Access Compliance Report

Public Rights-of-Way (Curb Ramps)

Intersection ID: 17792	Main Street: CHISWICK_RD	Cross Street: COLVILLE_RD	Location: S
ADA ID: 5C3E25AE870A	Ramp Type: Perp	Initial Pass/Fail: Pass	Overall Compliance: No
		Severity Score: 0

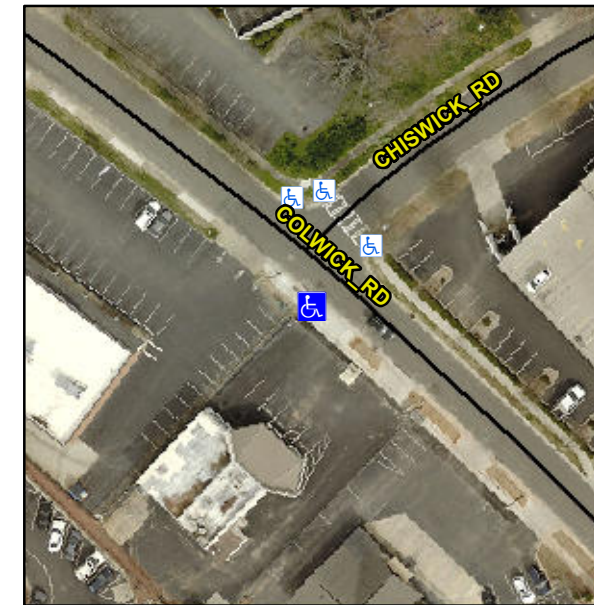
Not Found, R304.2.1

Remove & Replace Entire Ramp.
